**THE FIRST MEETING OF THE APANPIRG AERODROMES
OPERATIONS AND PLANNING – WORKING GROUP (AOP/WG/1)**

AMENDMENT 5 TO ANNEX 14, VOLUME II — HELIPORTS

This paper provides update on the new Amendment 5 to Annex 14, Volume II – *Heliports*.

Figure 5-9 Flight path alignment guidance markings and lights

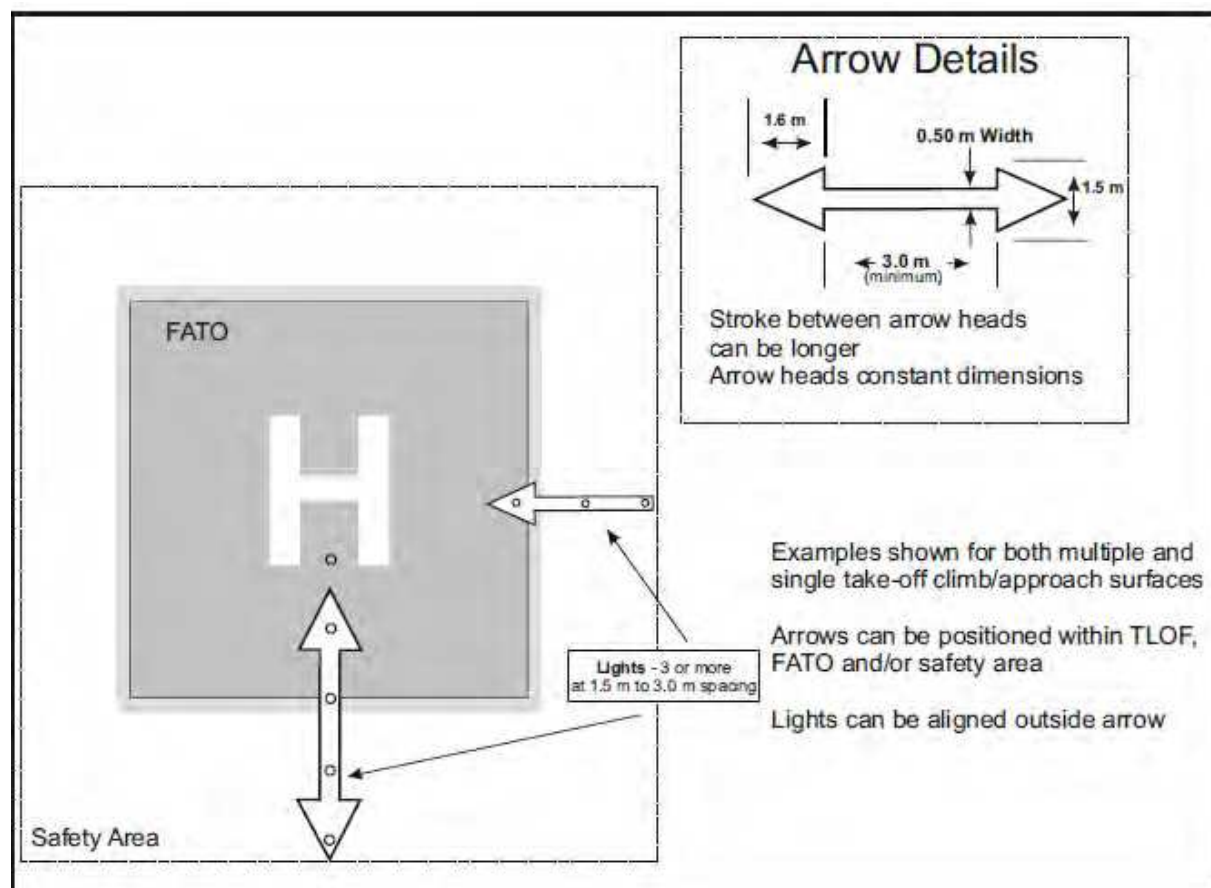
5.2.18.3 A flight path alignment guidance marking shall consist of one or more arrows marked on the TLOF, FATO and/or safety area surface as shown in Figure 5-9. The stroke of the arrow(s) shall be 50 cm in width and at least 3 m in length. When combined with a flight path alignment guidance lighting system it shall take the form shown in Figure 5-9 which includes scheme for marking ‘heads of the arrows’ which are constant regardless of stroke length.

Editorial Note.— New Figure 5-9:

5.3.4.4 Recommendation.— *A flight path alignment guidance lighting system should consist of a row of three or more lights spaced uniformly a total minimum distance of 6 m. Intervals between lights should not be less than 1.5 m and should not exceed 3 m. Where space permits there should be 5 lights. See Figure 5-9.*
